**TOWN OF NEWBURGH
PLANNING BOARD
TECHNICAL REVIEW COMMENTS**

PROJECT: MADAN SUBDIVISION
PROJECT NO.: 20-06
PROJECT LOCATION: SECTION 1, BLOCK 1, LOT 132
REVIEW DATE: 24 JUNE 2020
MEETING DATE: 2 JULY 2020
PROJECT REPRESENTATIVE: MECURIO-NORTON-TAROLLI-MARSHALL ENGINEERING

Re: Job No. 2822-110B
Tax Parcel 1-1-32
Town of Newburgh, Orange County
757 Orchard Drive
Residential Subdivision

Survey Map & Subdivision Plan for Lands of Robert P. & Deborah C. Madan

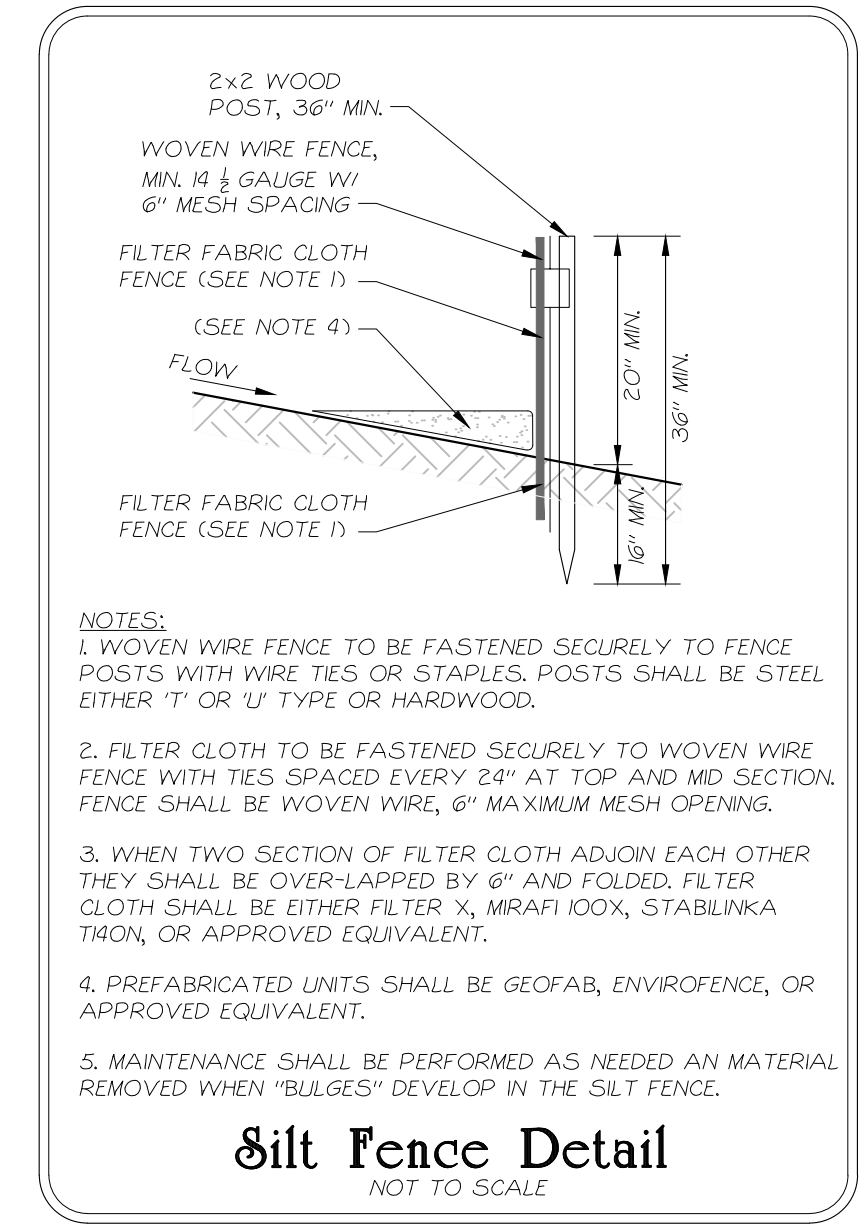
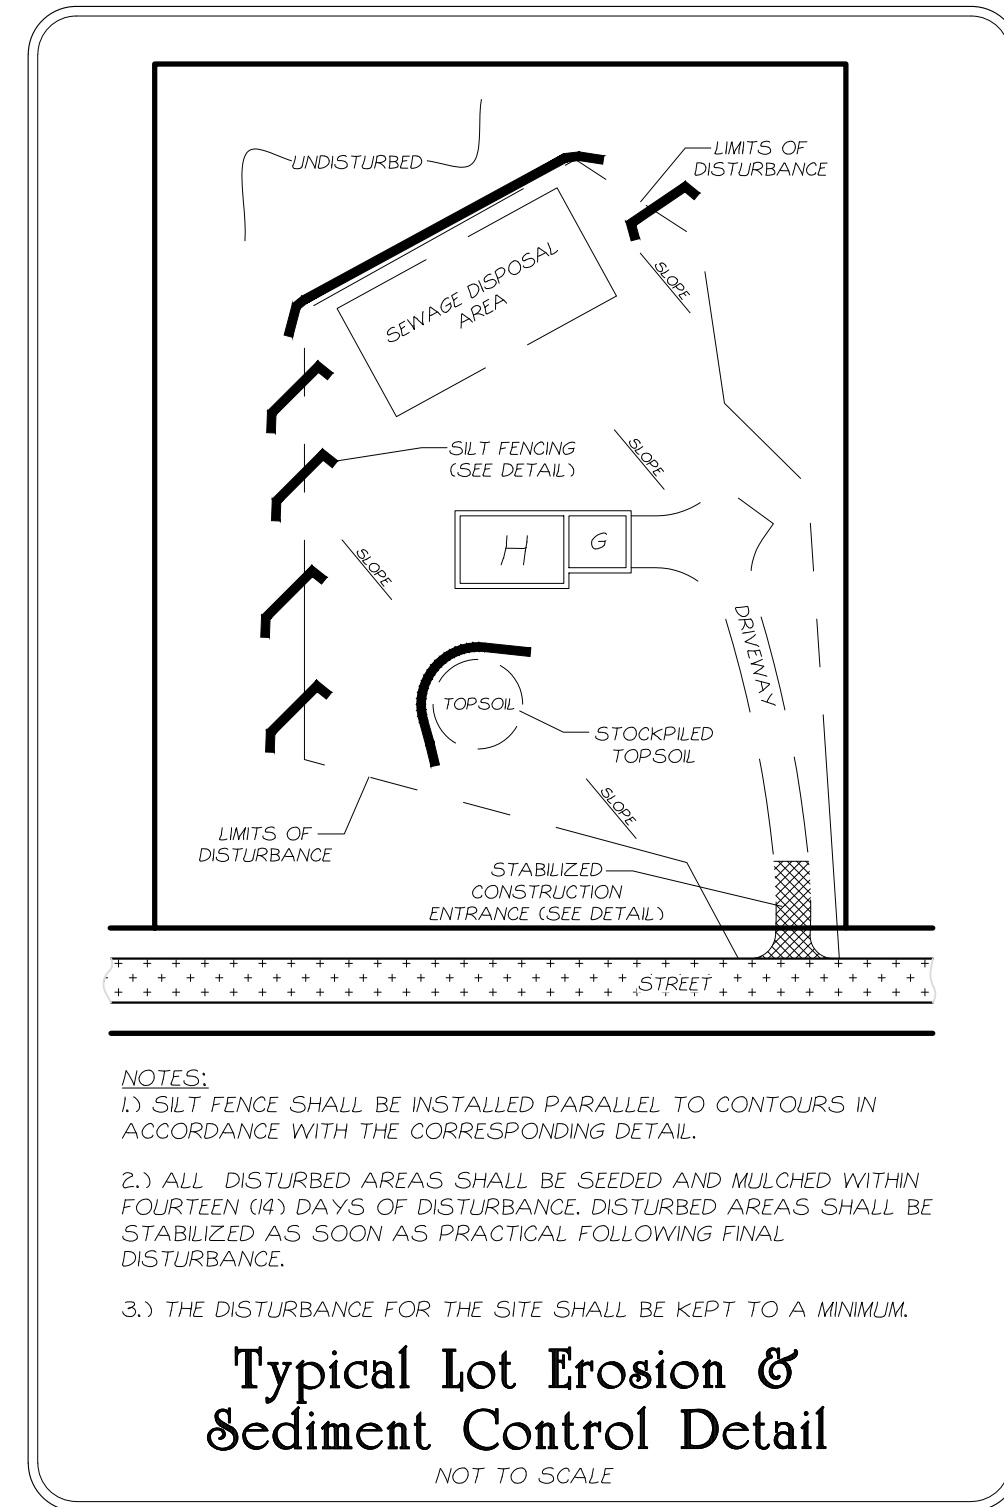
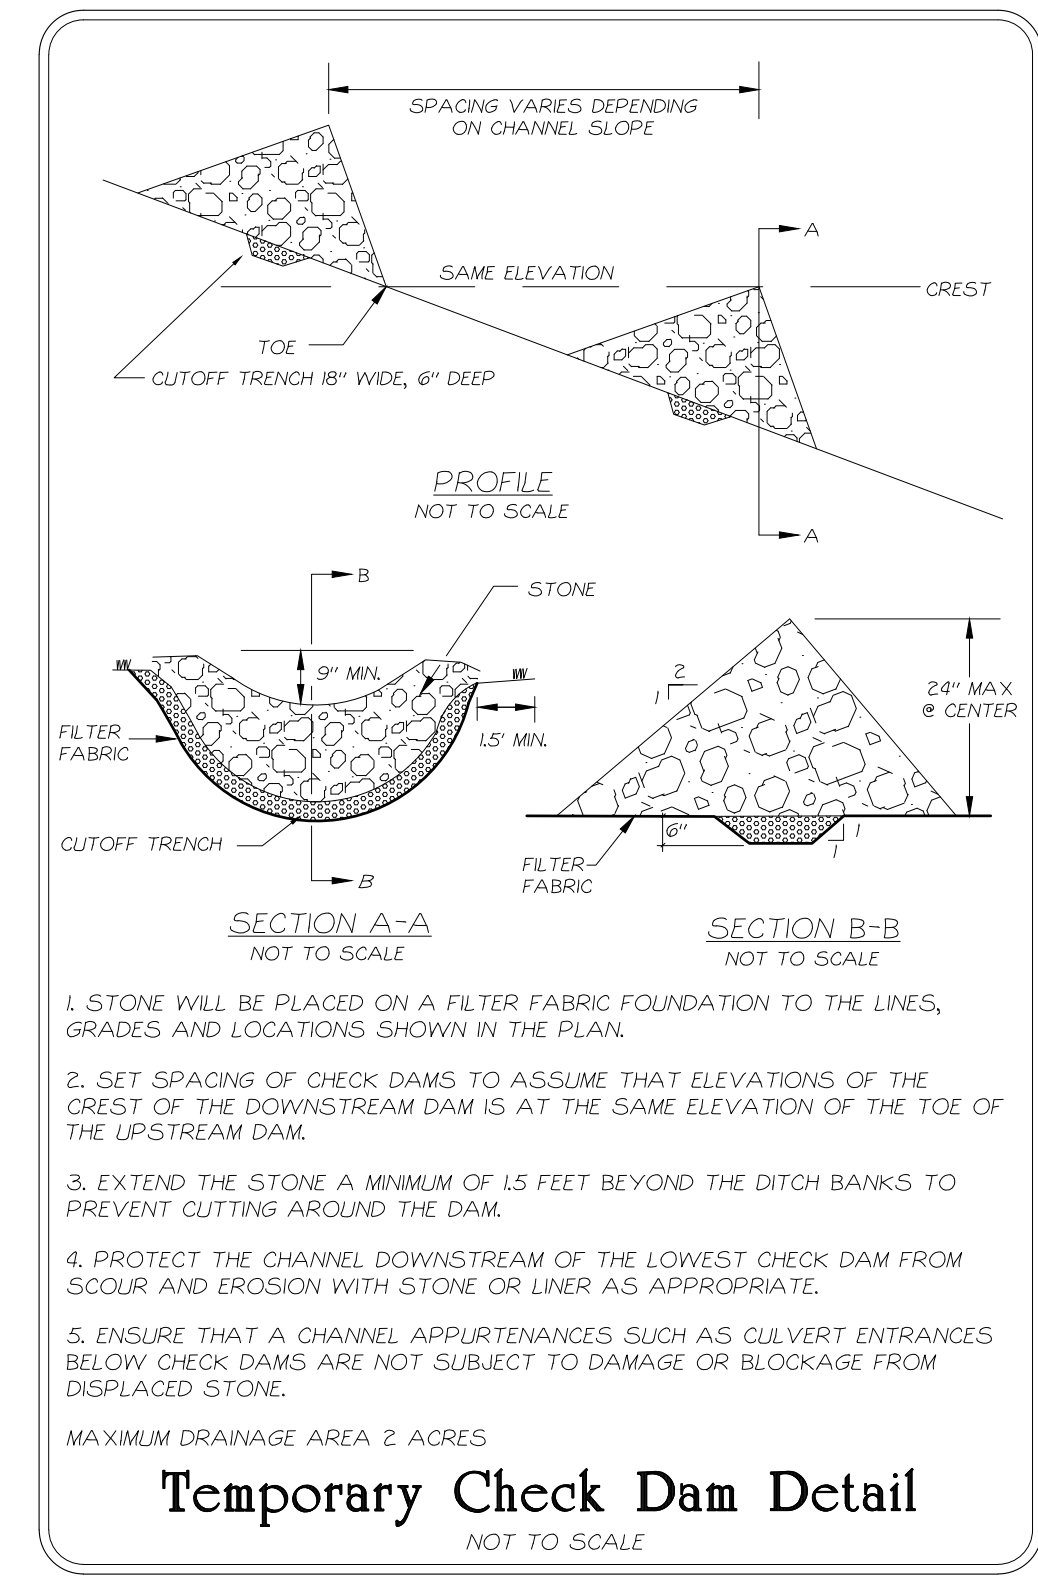
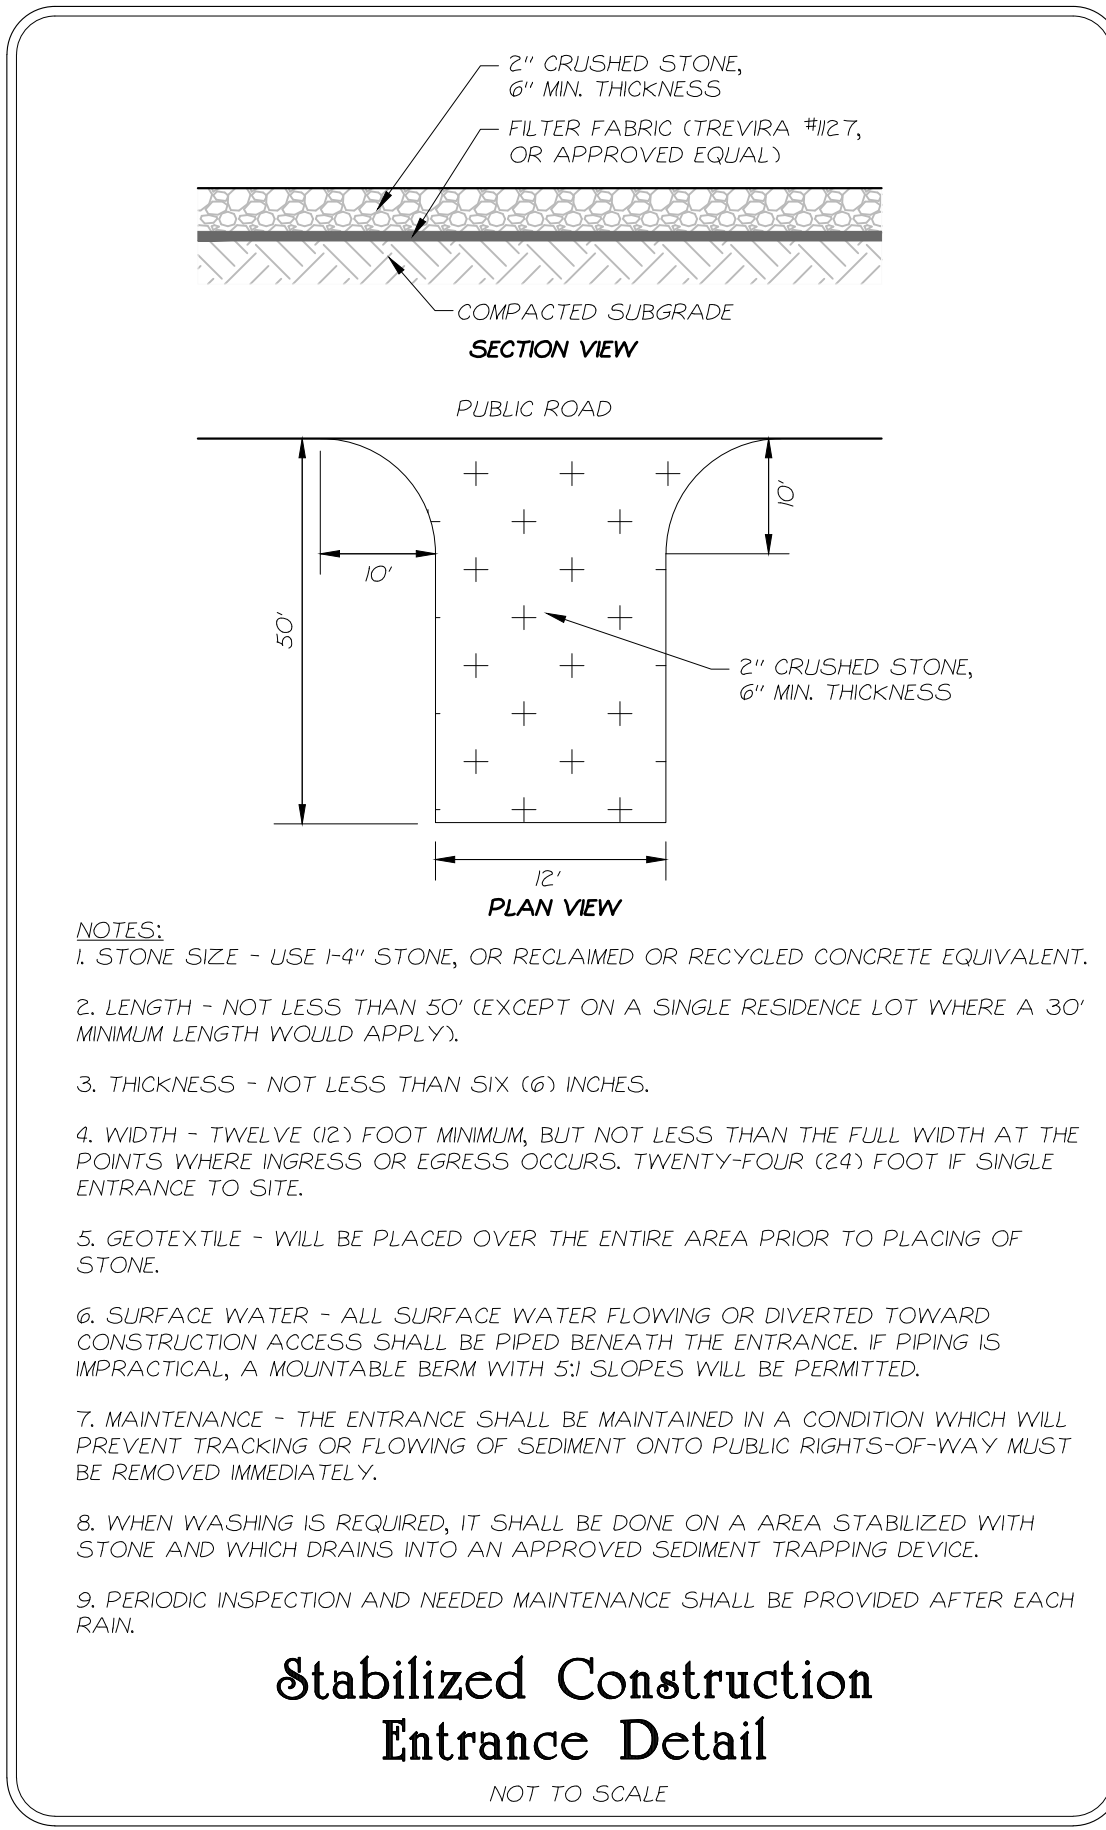
1. Comments from the Highway Superintendent on the driveway locations and clearing notes should be received.
2. The project will be circulated to the Town of Plattekill as it is located on the Town of Newburgh/Town of Plattekill Town line.
3. Any conditions of approval should include the relocation of the utilities serving the existing structure prior to filing of the map.

1. The proposed utility easement has been widened to 20-feet. The applicant has agreed to relocate the utility line prior to the filing of the subdivision map. We anticipate this will be a condition of approval for the maps the signed.

3. Note 10 has been included on sheet 1 referencing the required as-built sewer certification prior to the issuance of a certificate of occupancy. If different wording or notation is required, please advise.
